**ADDENDUM NO. 1**  
**PARKER SWAMP DRAIN**  
**SAGINAW COUNTY, MICHIGAN**

**RE: CHANGES TO BIDDING DOCUMENTS**

**Parker Swamp Drain  
Mandatory Pre-Bid Conference  
10:00 A.M., May 19<sup>th</sup>, 2022  
Saginaw County Public Works Commissioner**

**PARKER SWAMP DRAIN  
PLAN AND PROFILE  
STA 82+31 TO STA 111+24**

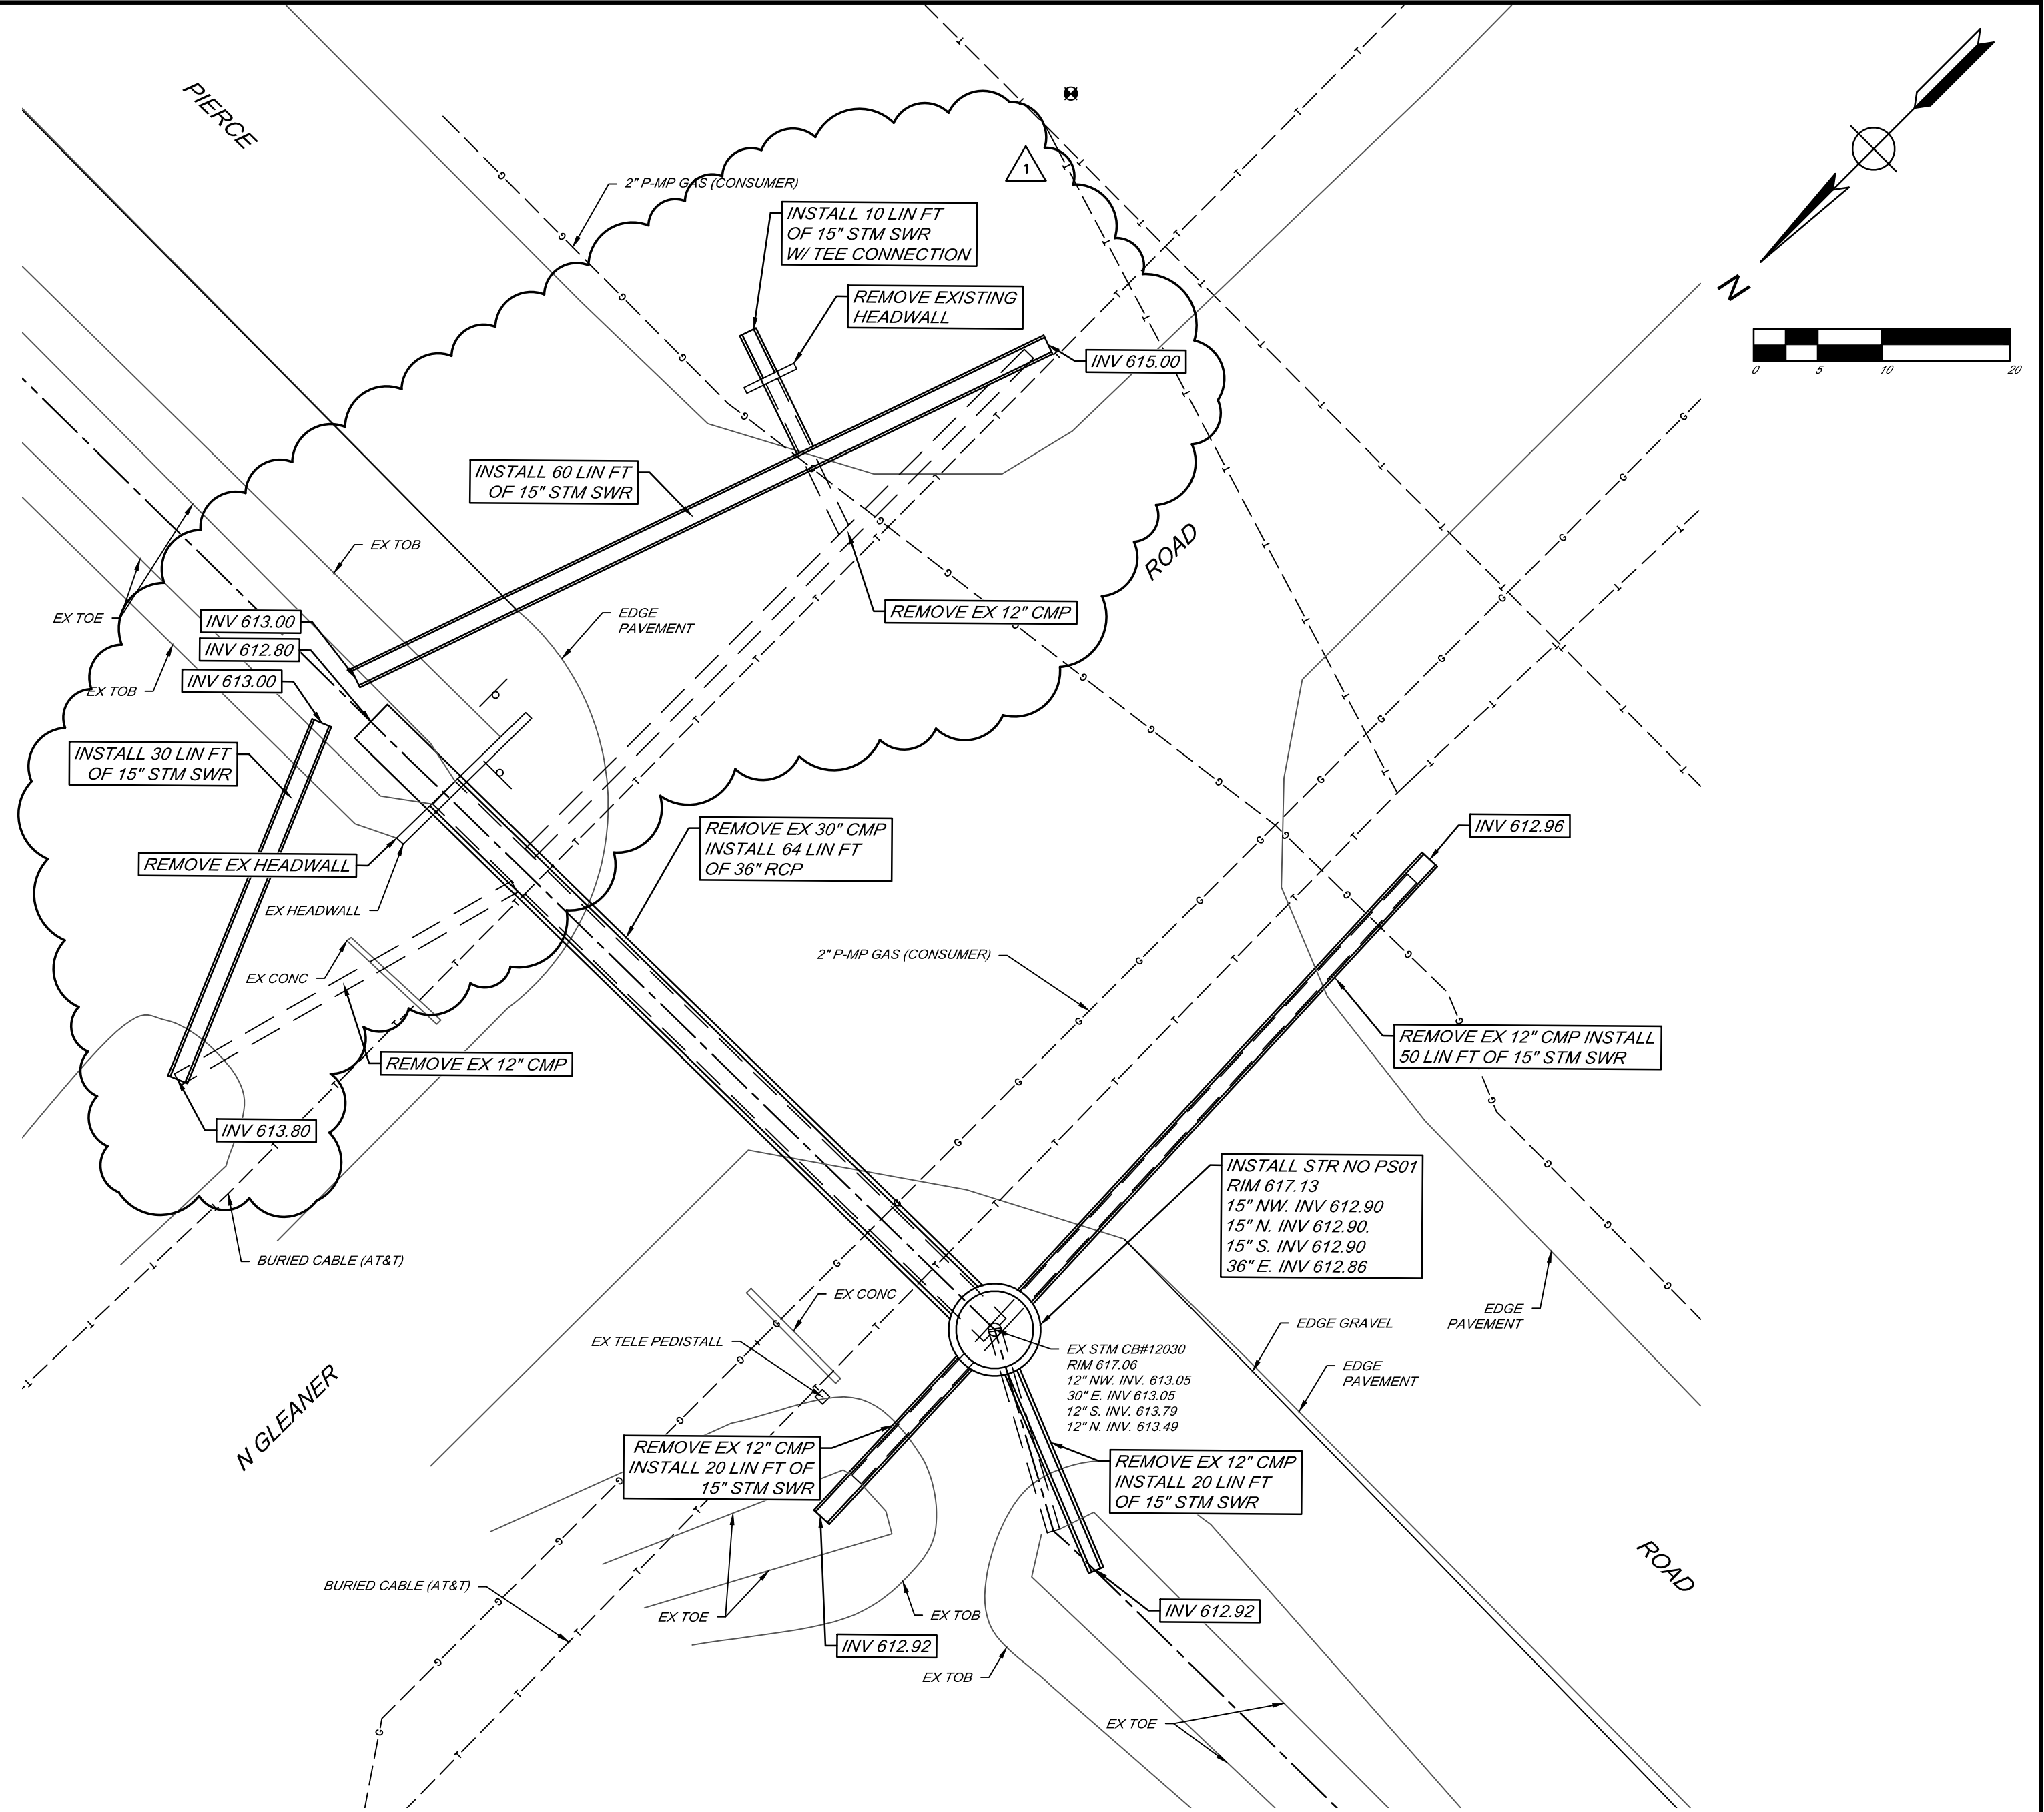
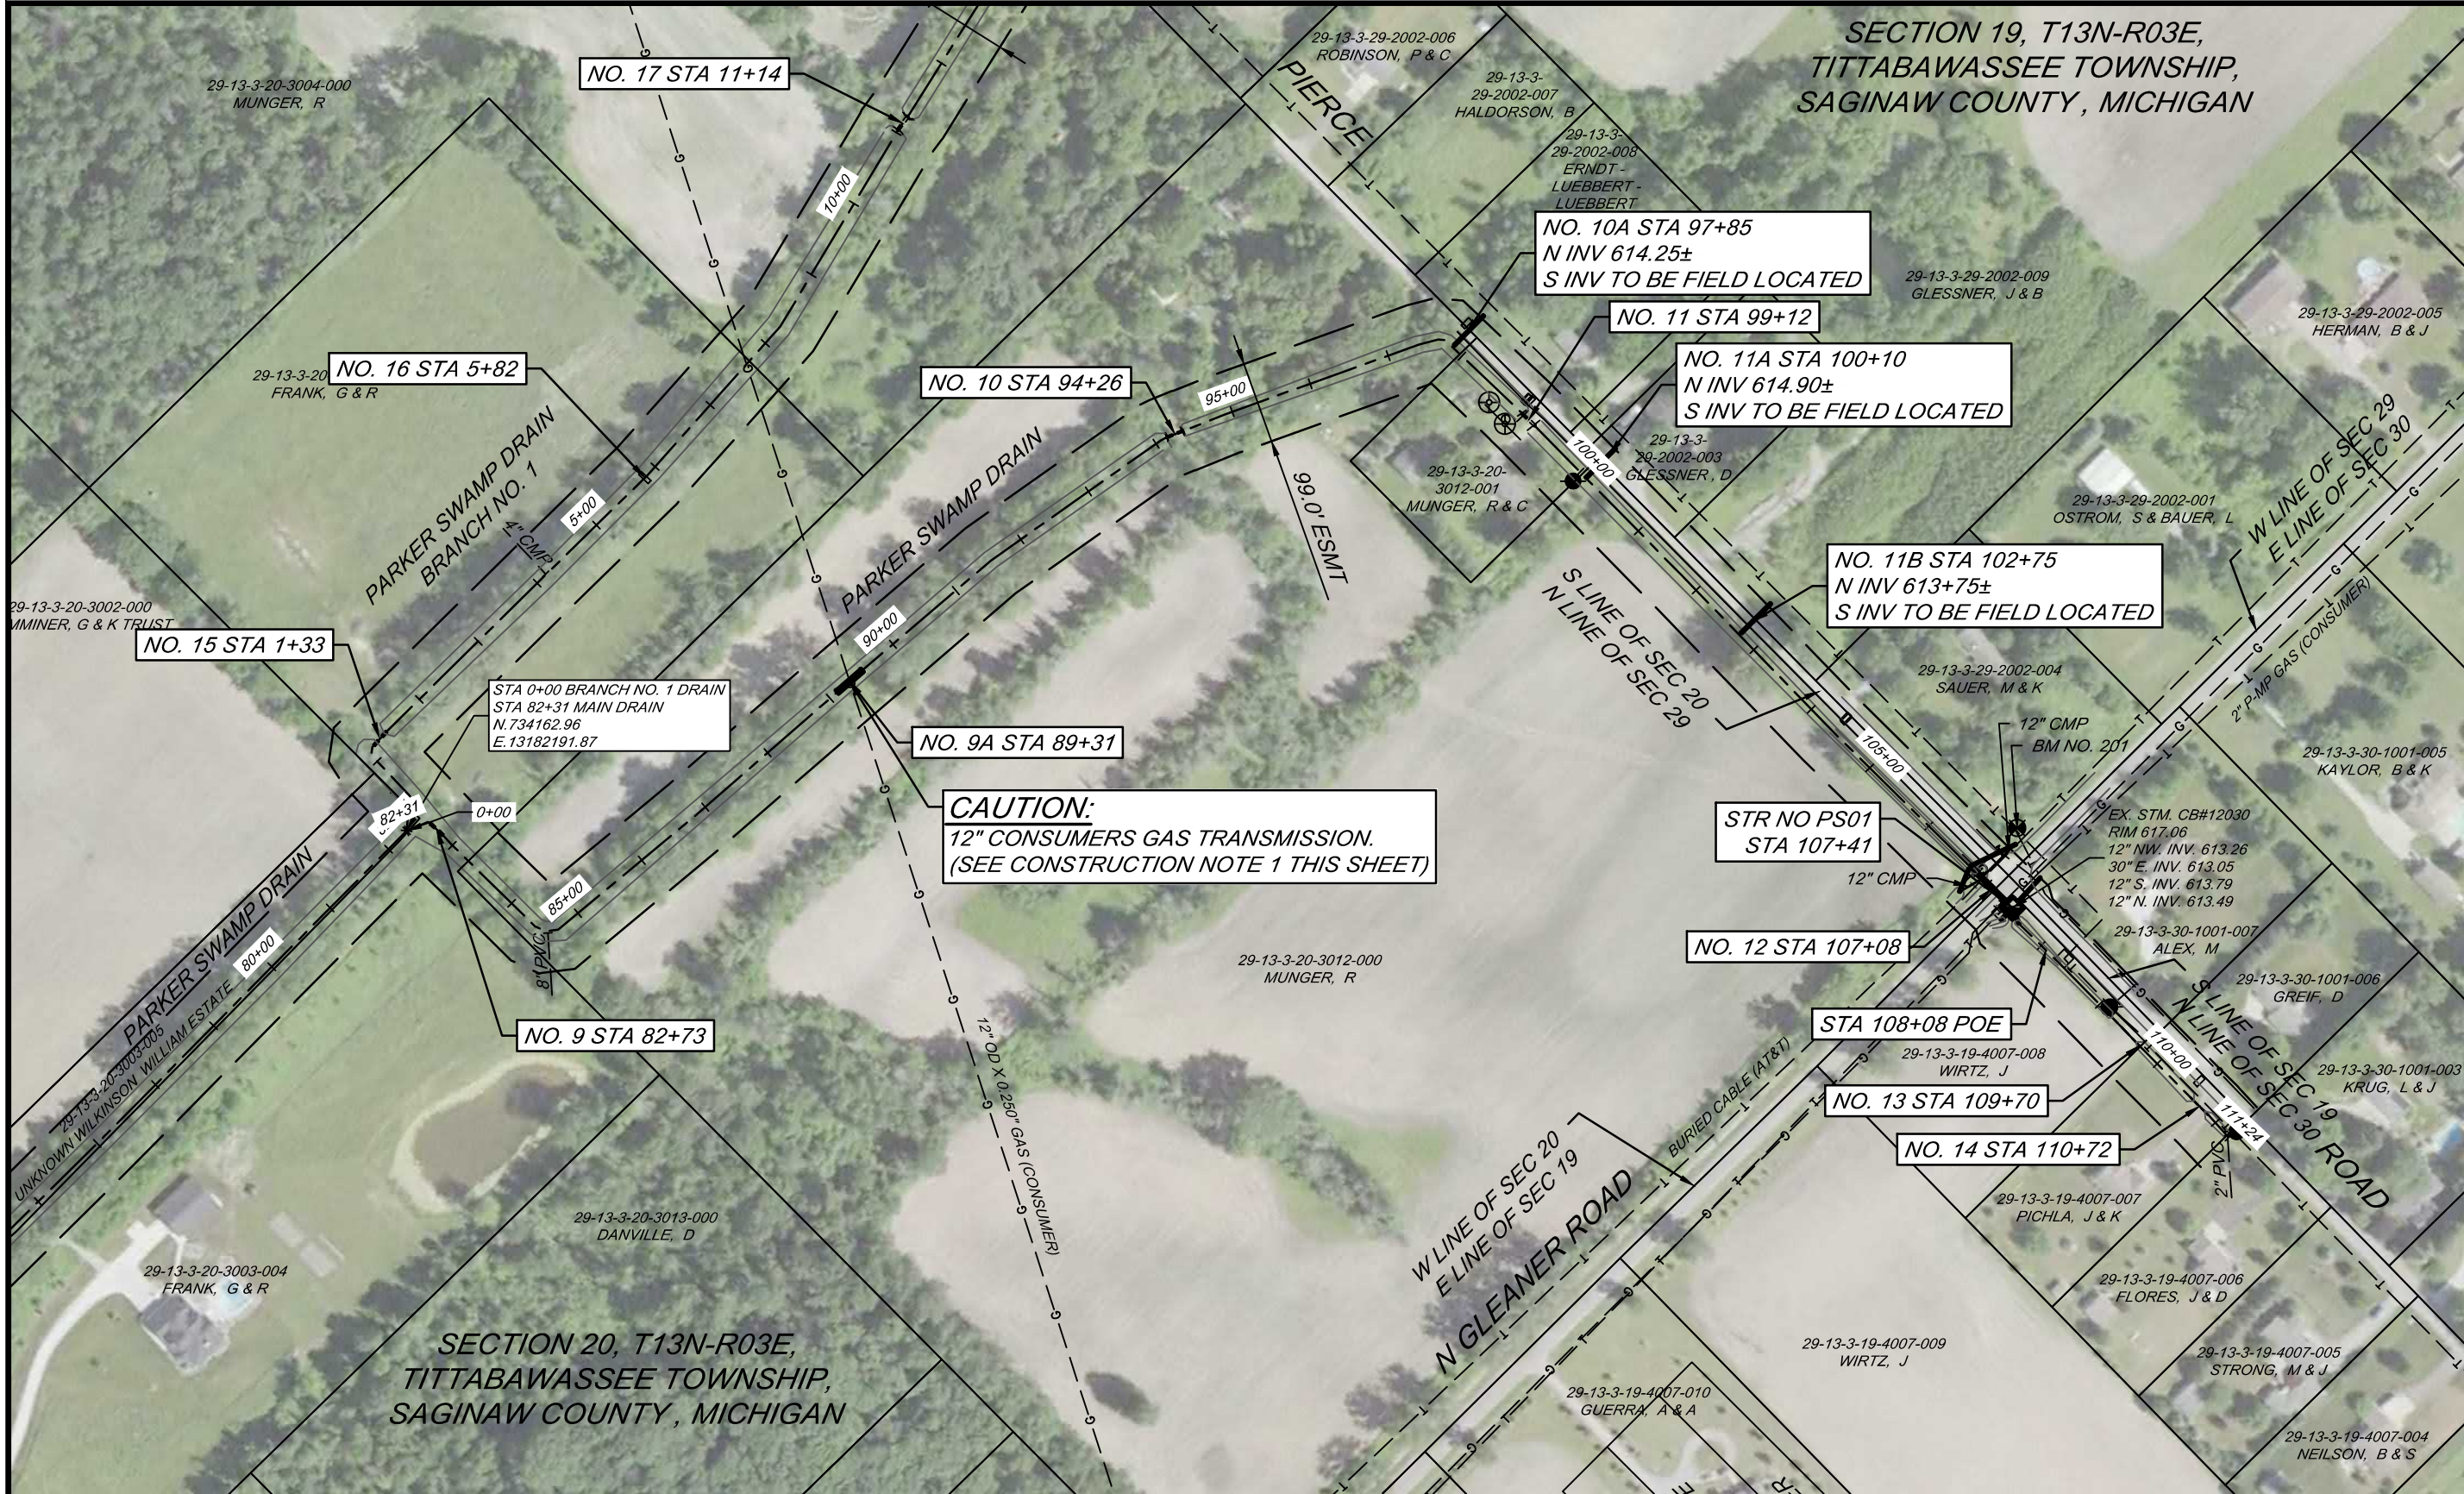
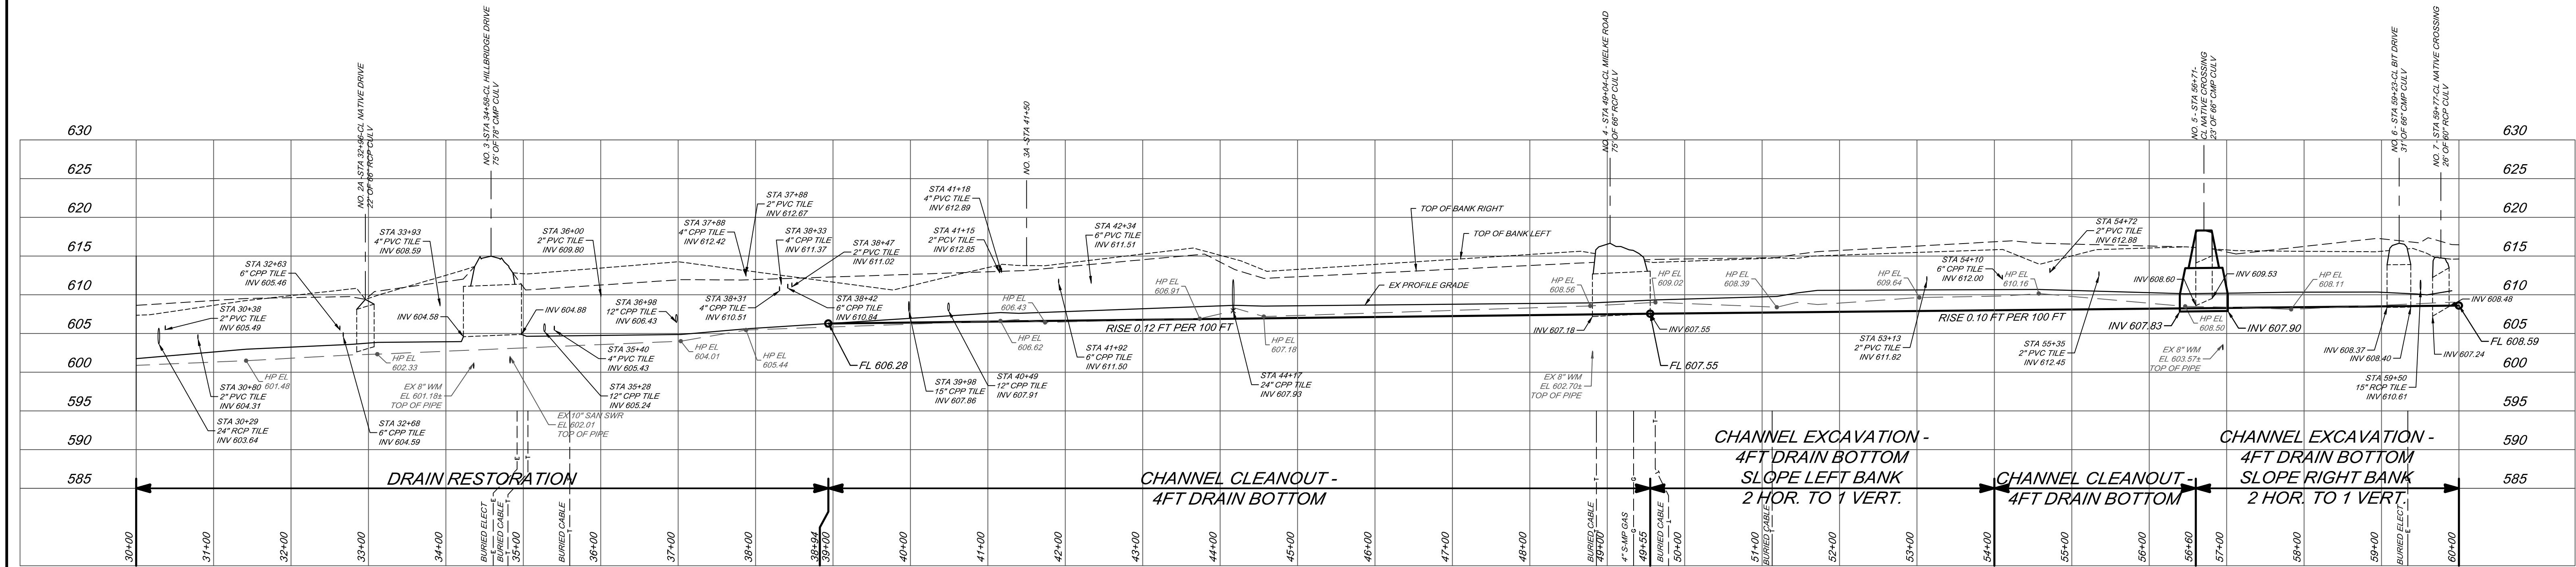
1. Addendum No. 1 has been emailed to you on Monday, May 23<sup>rd</sup>, 2022.
2. Enclosed please find the following attachments pertaining to Addendum No. 1
  - Mandatory Pre-Bid Meeting Minutes
  - Attendance Sheet from Mandatory Pre-Bid Meeting
  - Revised plan sheets:
    - i. DR-4246-06
      1. Updated spoil leveling table
    - ii. DR-4246-08
      1. Added cross culvert and maintenance access culvert to Gleaner and Pierce Road Crossing Detail

***Issue new DR-06 sheet, DR-08 sheet, as well as updated bid form***

SPOIL LEVELING TABLE			
STATION FROM	STATION TO	DETAIL	SIDE TO EXCAVATE FROM
30+00	41+75	HAUL	RIGHT
41+75	56+71	HAUL	LEFT
56+71	60+00	HAUL	RIGHT
